**ZAP COMMISSION SITE PLAN REVIEW SHEET
ENVIRONMENTAL VARIANCE
CONDITIONAL USE PERMIT
HCRO DEVELOPMENT BONUS**

CASE: SPC-2016-0055C **PLANNING COMMISSION DATE:** February 21, 2017

PROJECT NAME: Junior league Community Impact Center, District 10

CITY OF AUSTIN – DEVELOPMENT SERVICES DEPARTMENT
SITE PLAN APPLICATION – MASTER COMMENT REPORT

Junior League of Austin
Community Impact Center
5330 Bluestone Lane
Austin, TX 78759
Critical Environmental Feature

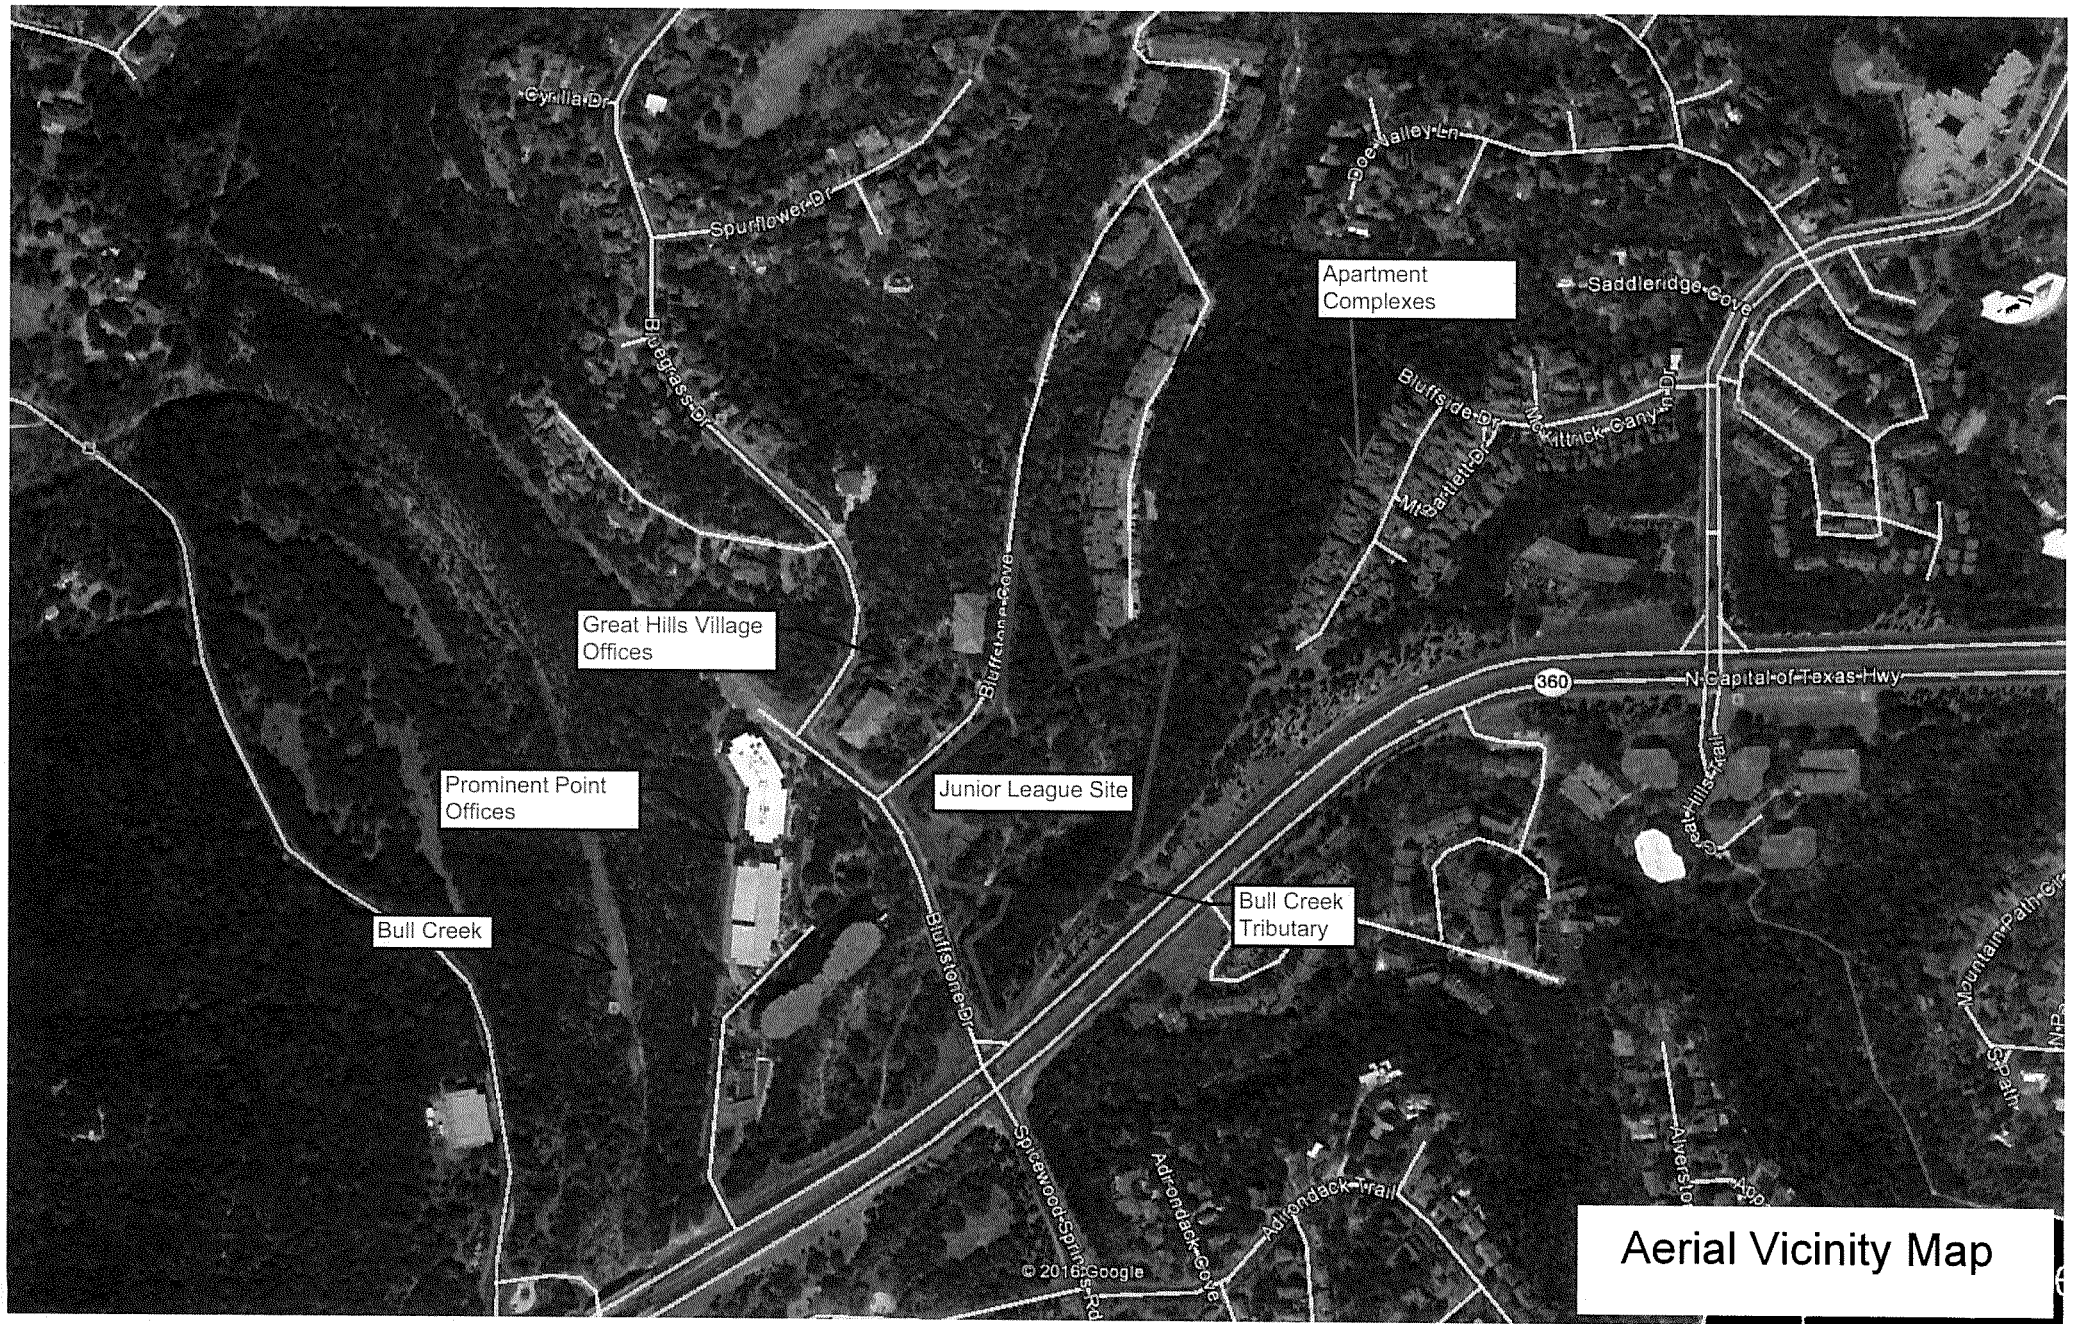
Reference sheet 10 for an overall view of the property, including the critical environmental features and setbacks. The floodplains associated with the Bull Creek Tributary No. 2 are also shown on this plan. The 2008 FEMA floodplain is delineated and labeled "FEMA". The calculated floodplain as delineated by the City of Austin Bull Creek Drainage Study is also delineated.

Cut Fill Exhibit

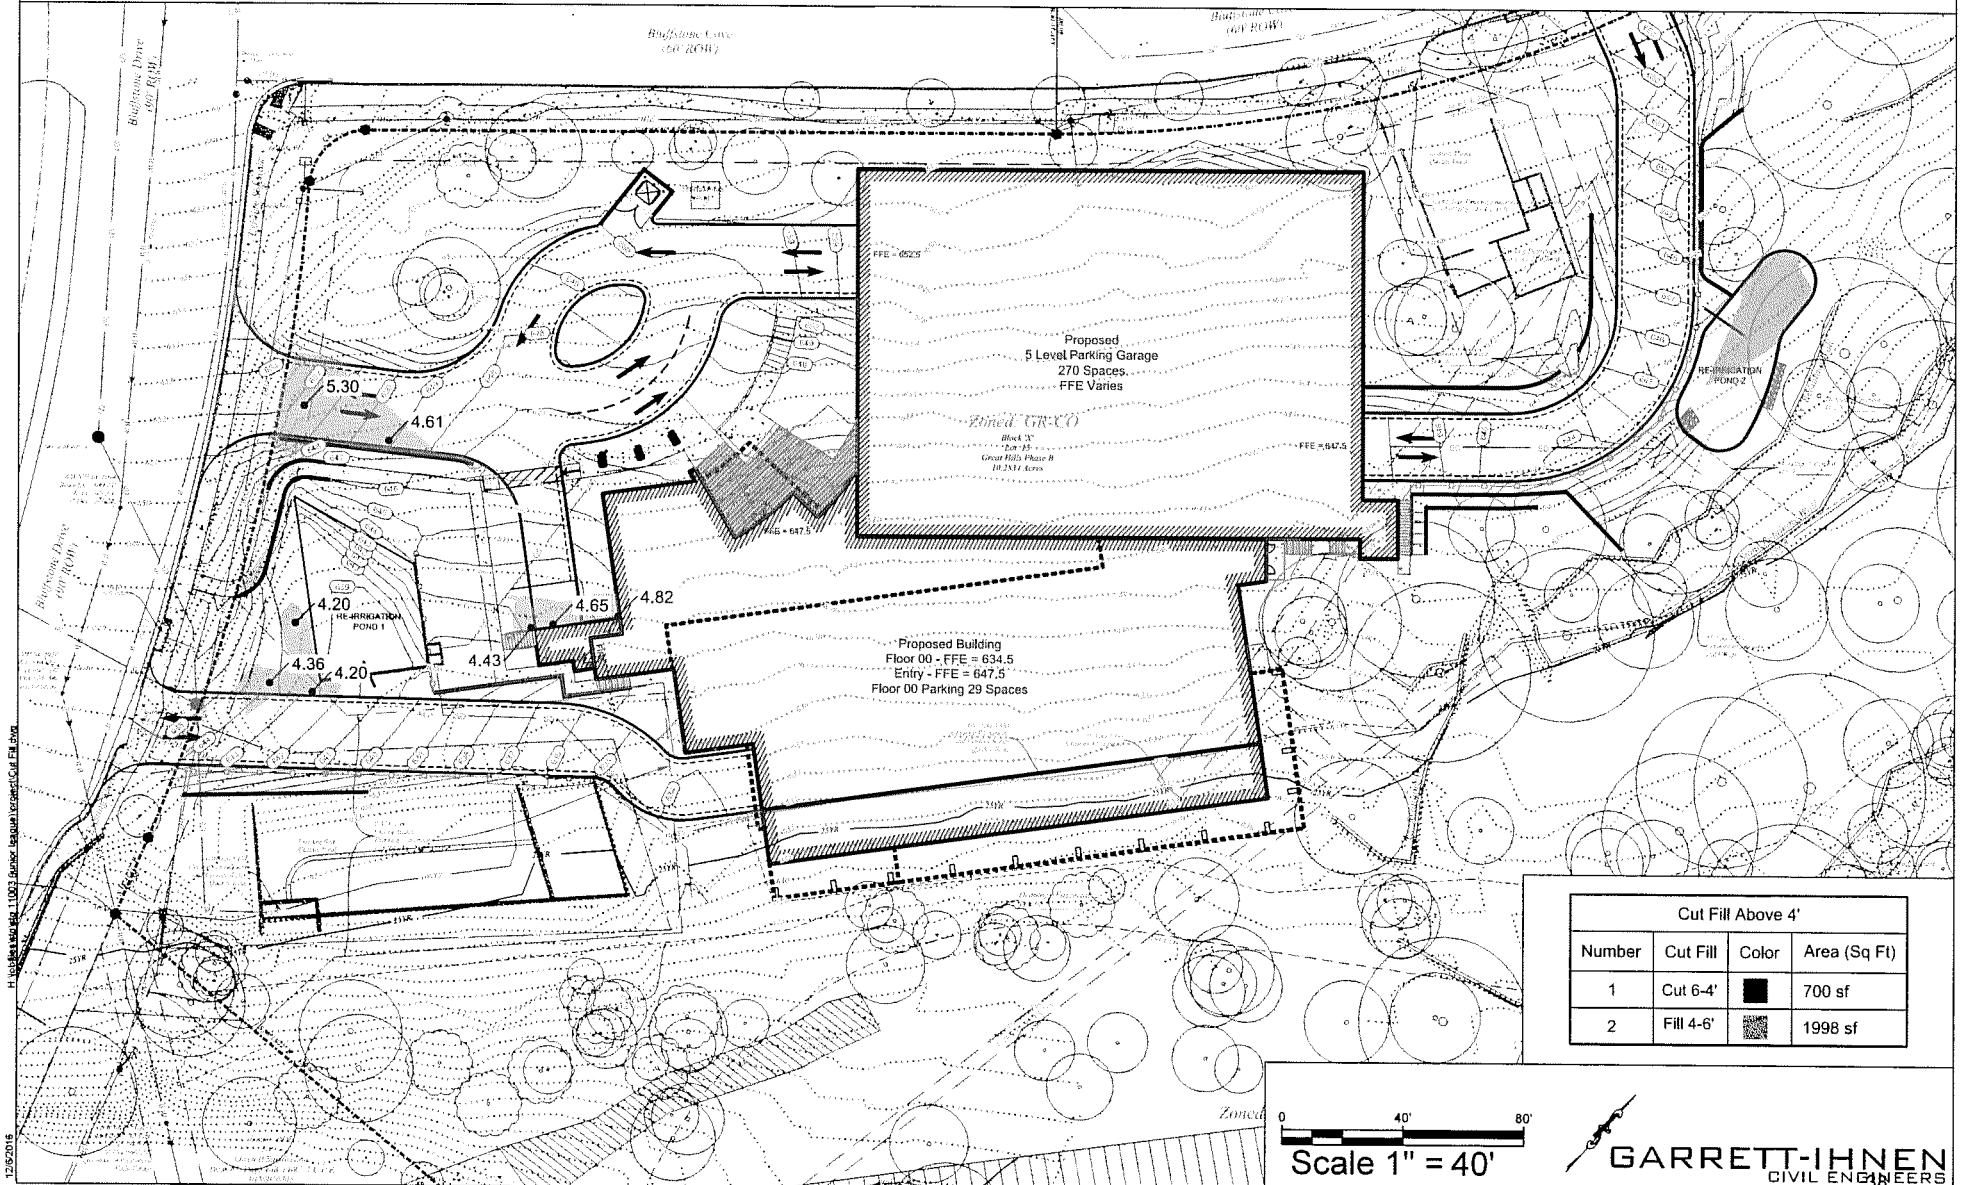
§13-15-235 (Cut above 4 feet): The 700 SF of cut between 4 feet and 6 feet is associated specifically with the location required for a retention/re-irrigation pond to the east of the proposed structure. The small window available for development on the site requires separate retention/re-irrigation facilities due to the topographic constraints, Critical Environmental Feature buffers, protected trees, floodplain, and waterway setbacks on the site. This eastern pond is required to treat runoff from a portion of the garage and the eastern entrance to that garage.

§13-15-235 (Fill above 4 feet): The 1,998 SF of fill between 4 feet and 6 feet is associated with the western retention/re-irrigation pond required by the Settlement Agreement, the primary entry drive onto the site, and a required loading area on the south side of the building.

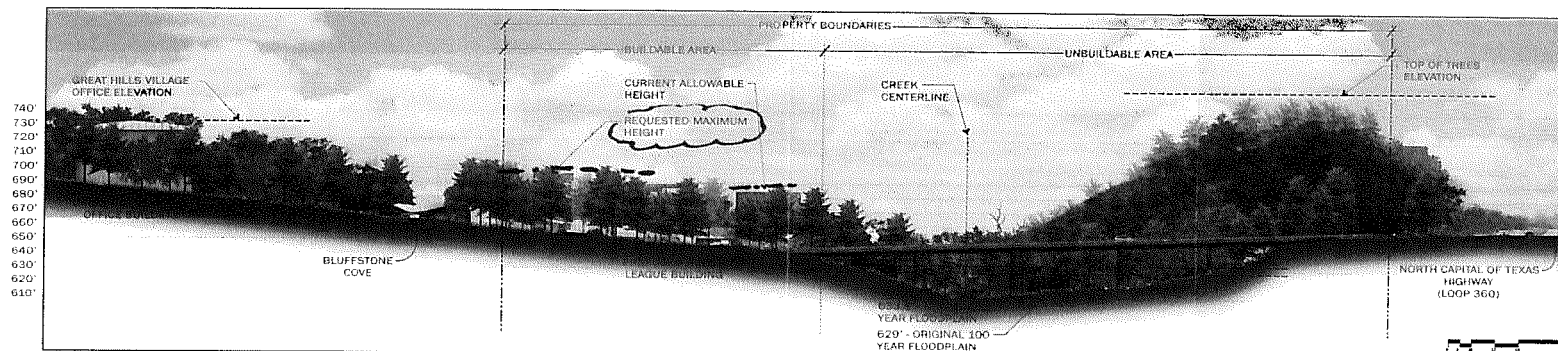
These areas of building and parking on slopes between 15% and 25% account for less than ½ of 1% of the total site area (0.42%). Certainly, these very small areas could be considered de minimus, much as they were on the nearby Prominent Point II PUD (Case C814-06-0054) in 2006, where similar conditions were apparent.

Staff requested in a meeting on May 12, 2016 that the JLA Community Impact Center project base the slope calculations on actual survey data, as opposed to City-provided, LIDAR-generated topographic maps. Accordingly, this project re-developed a slope map based on recent survey data in response to this request, and re-generated the building and parking areas on slopes greater than 15% based on this new slope map.

At the same meeting, the staff also provided some suggestion that a de minimus quantity of buildings and parking areas could occur on slopes greater than 15% and still meet the intent of this criteria, stating specifically that values of less than 3-5% could be considered acceptable. This project has less than 2.7% of building and parking areas on slopes greater than 15%, and should therefore address this concern.
